Subject: Response to Request for Additional Information
Southeast County Landfill, Hillsborough County
Capacity Expansion Section 8
Certification of Construction Completion
Permit No. 35453-009-SC
Jones Edmunds Project No. 08449-020-01

Following our meeting on June 14, 2006 to discuss the Section 8 Certification of Construction Completion Report (Report), you had requested some additional information to be submitted to our office to assist you with completion your approval of the Report. The additional information that you requested is listed below.

FILENAME
S.E. HILLSBOROUGH
RECORD
DRAWING #
RD-2

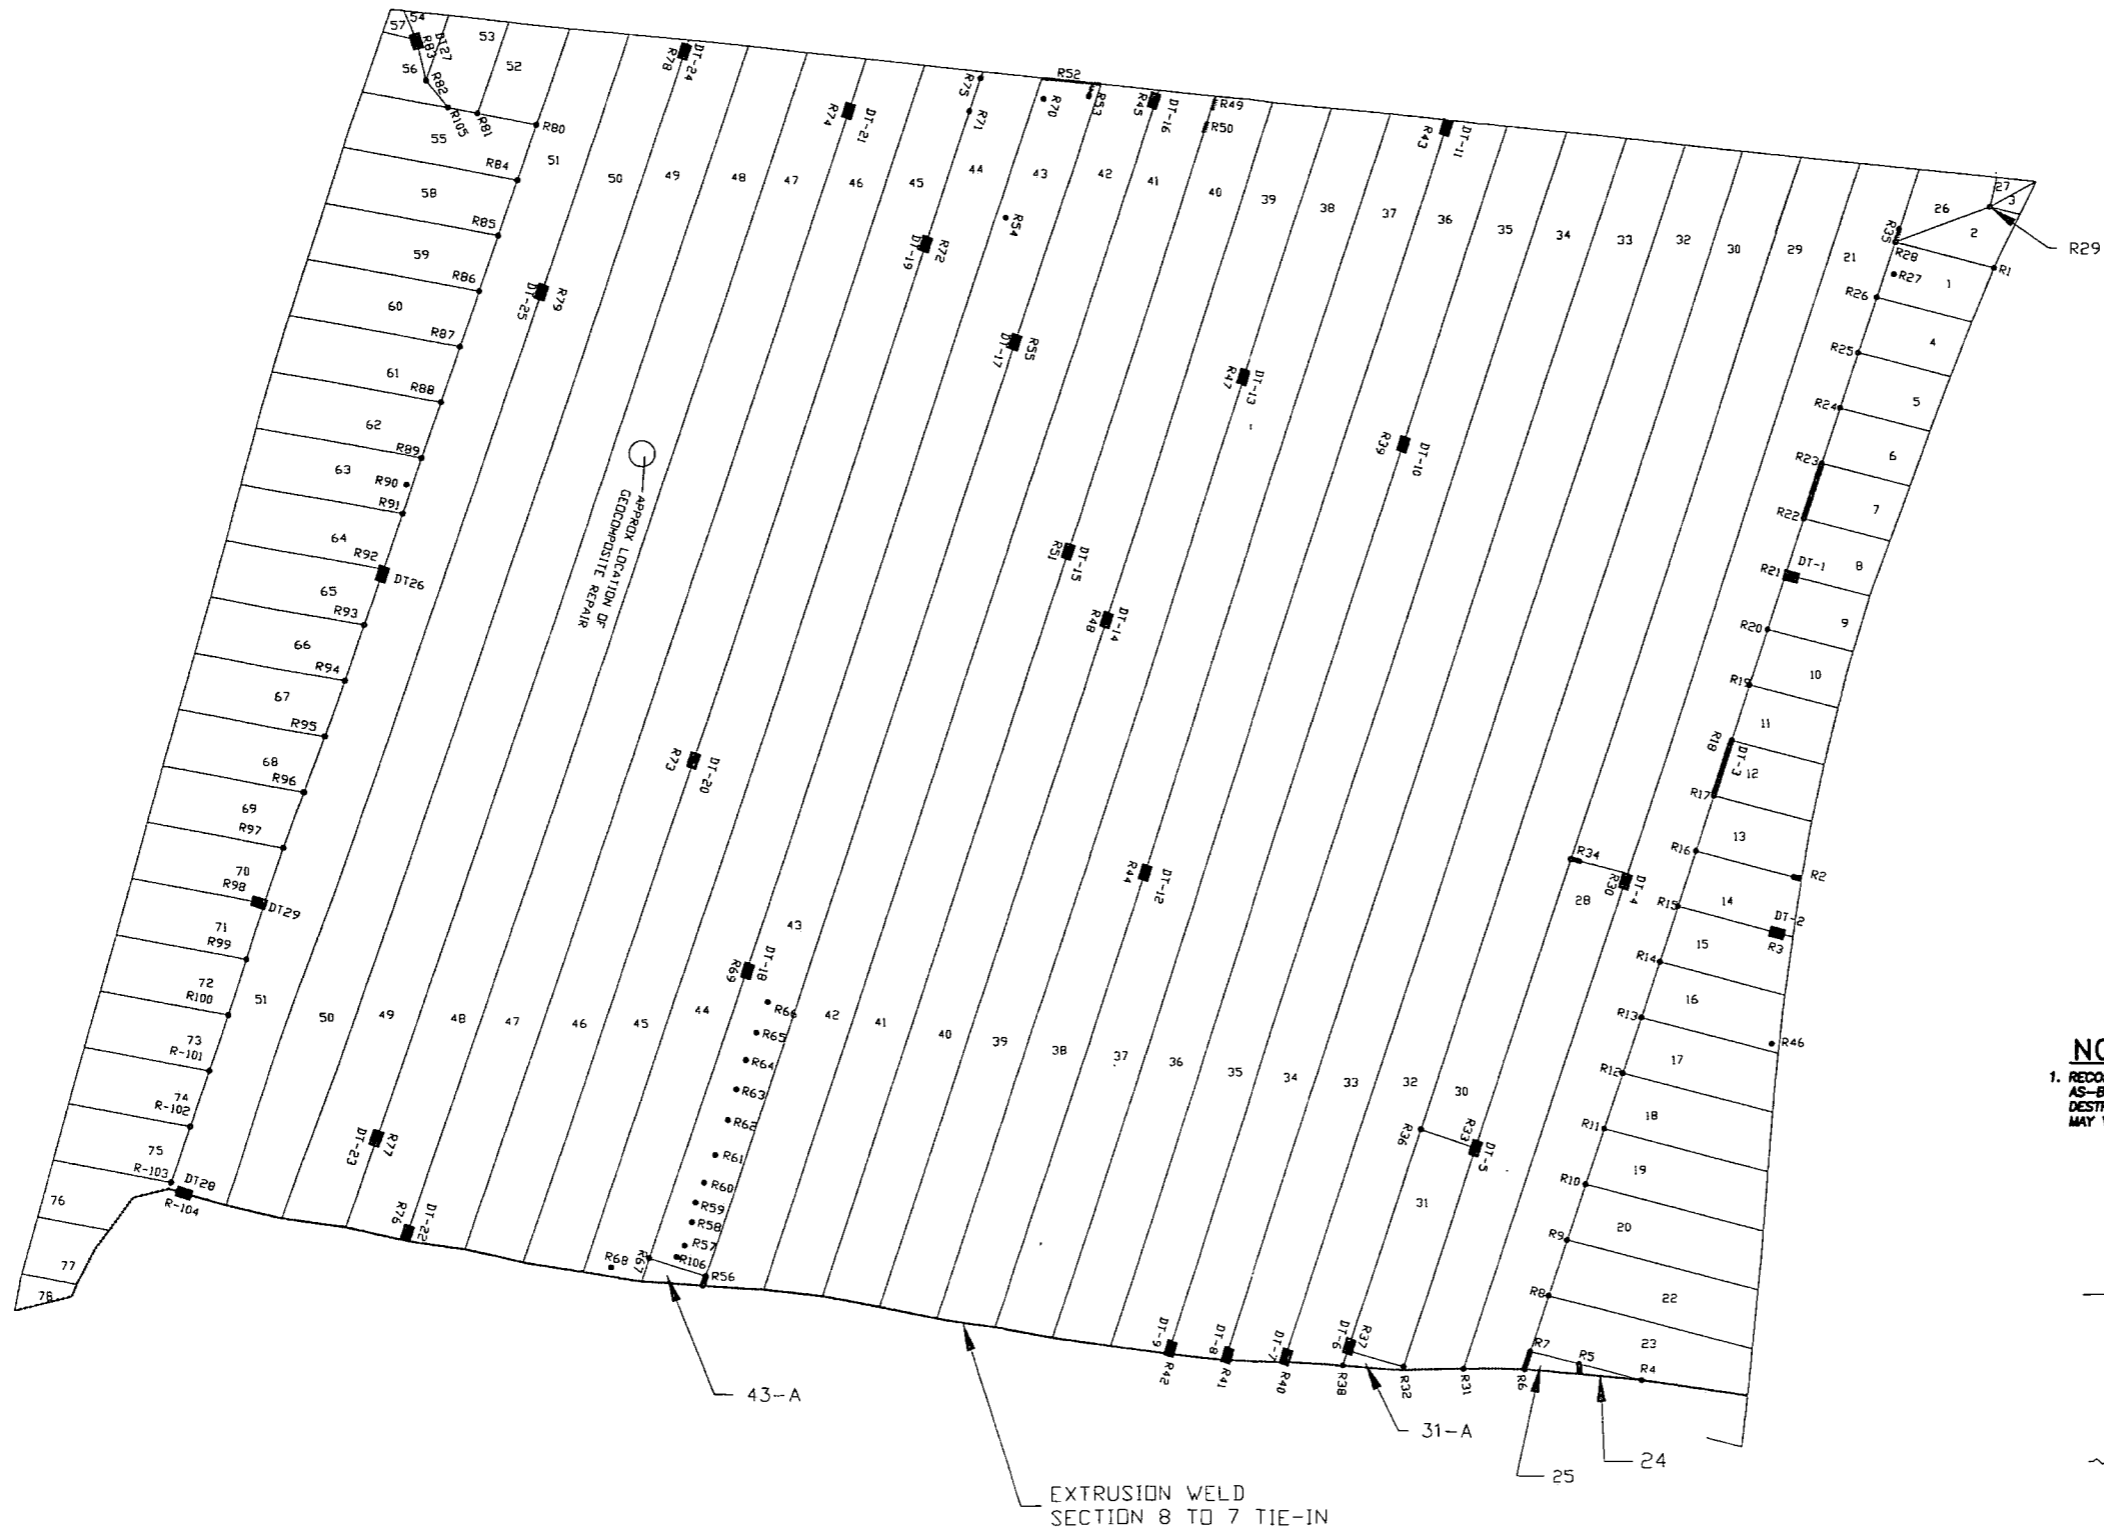
Comment 2) Please provide a revised Geomembrane Panel Layout that shows the "tear" mentioned in the field notes on the primary geomembrane panel layout. The "tear" was mistakenly placed on the secondary panel layout (Refer to the Department Comment Number 3.c.4).

Response 2: A revised Geomembrane Panel Layout is provided in Attachment 1 with the corrected location of the geocomposite "tear".

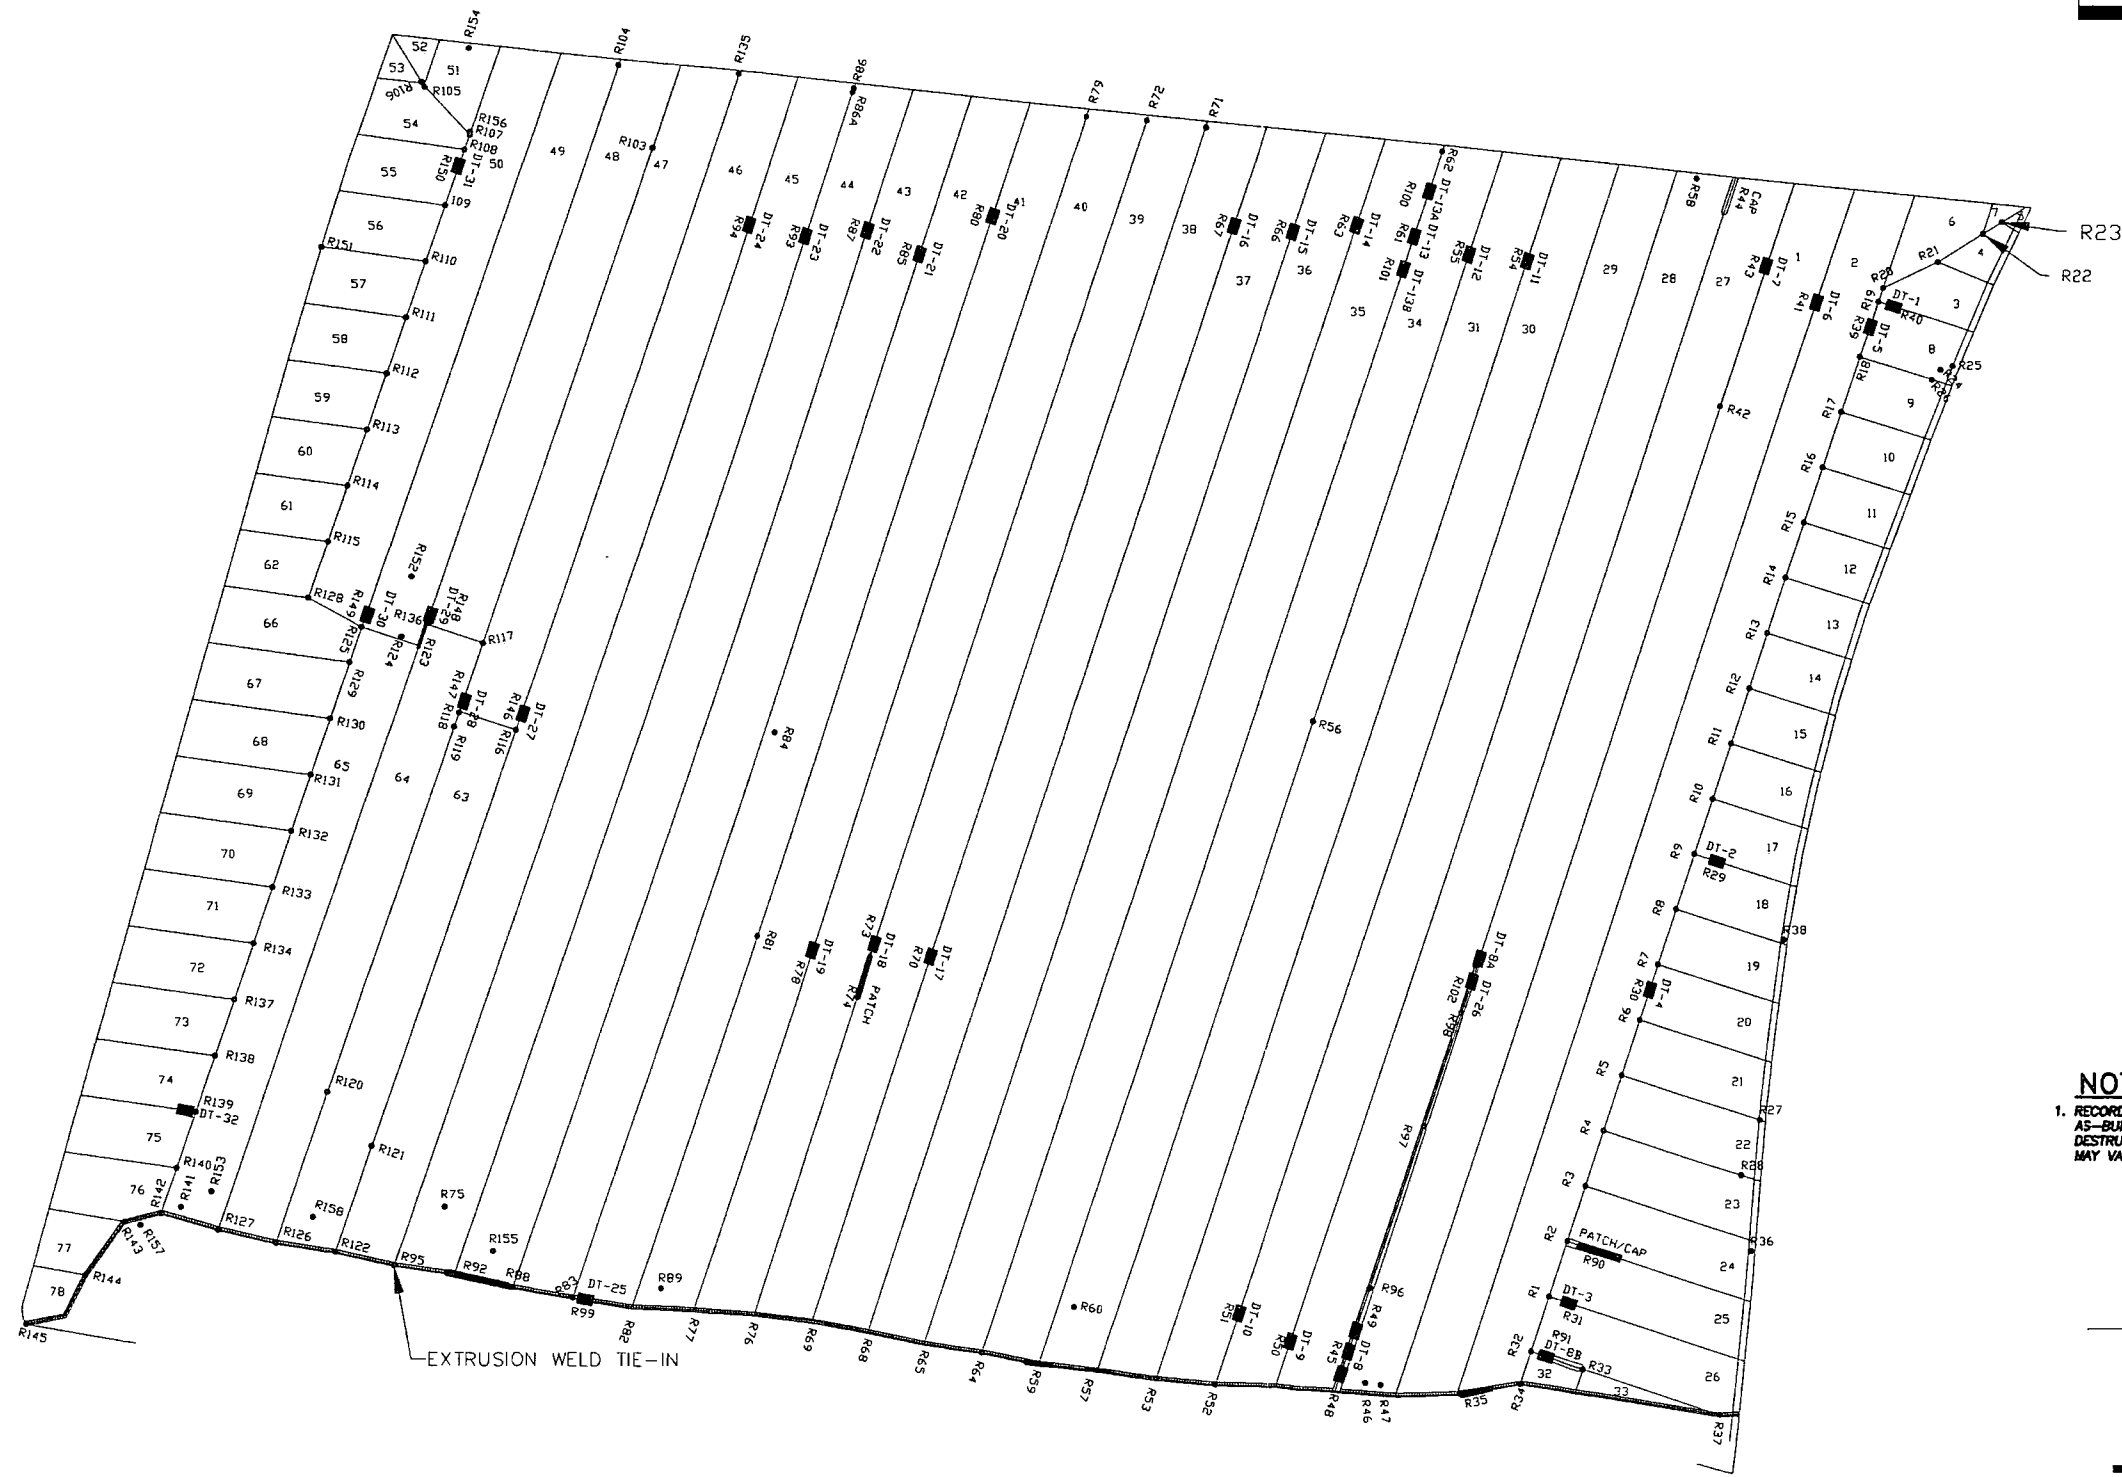
Comment 5) The "cap" repair is shown on the northend of the Panel 27/28 does not have a repair number. Please clarify if the repair is actually on Panel 27/28. If present, please provide a repair number, repair logs, or a revised Geomembrane Panel Layout.

Response 5: We have reviewed the repair logs, non-destructive logs, and coordinated with the QES Field QA technician and it appears that Repair No. 44 was mistakenly placed in the wrong location on the as-built panel layout drawings. Repair No. 44 (identified as "CAP") should have been placed on the north end of seam 27/28. A revised secondary panel layout drawing is provided in Attachment 1.

HILLSBOROUGH COUNTY
SOUTHEAST COUNTY LANDFILL
SECTION 8 SITE A
LEACHATE PIPE SETTLEMENT CALCULATION
FIGURE 1. SITE PLAN

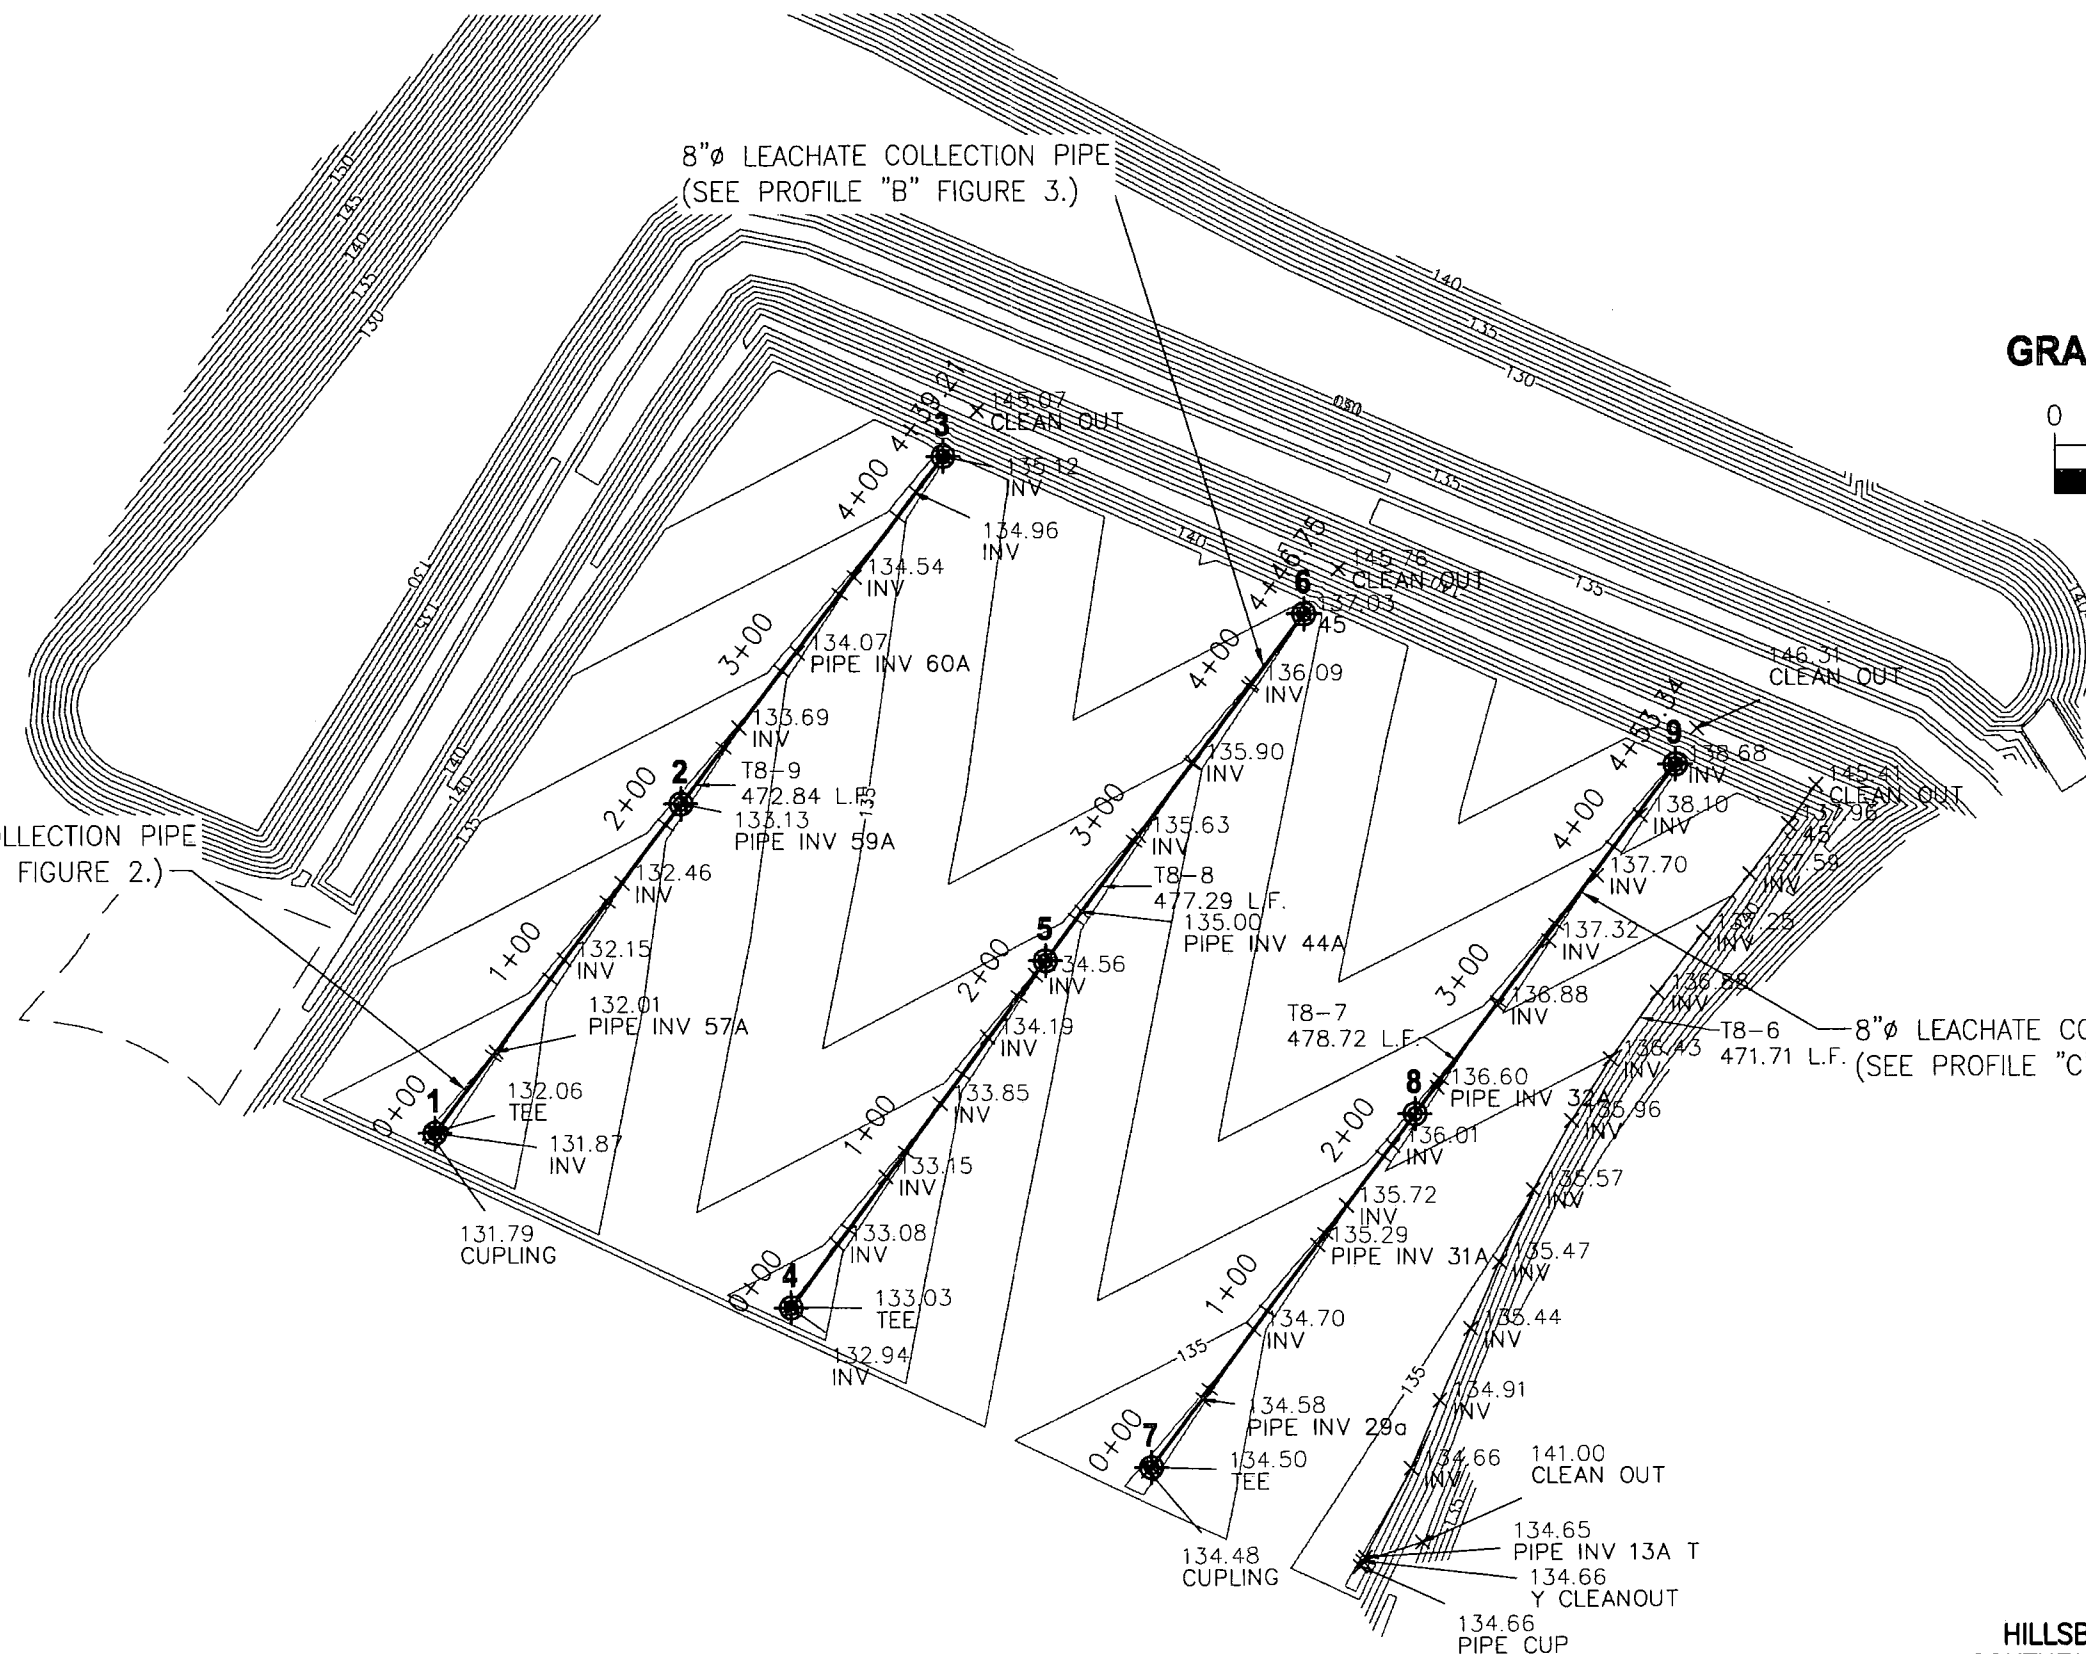
Comment 8) Please provide a Section 8 pipe profile for each leachate collection line with settlement estimates (Refer to the Department's Comment Number 4.a) .

Response 8: Provided in Attachment 5 is a profile of each pipe based upon information supplied by Pickett and Associates during construction. In addition, settlement

estimates were preformed by SCS Engineer's for the filling of Sections 7, 8, and 9 and Final Buildout of Site "A". The as-built and projected pipe profiles are contained in Attachment 5. Conclusion, the pipes will have positive slope drainage towards Section 7.
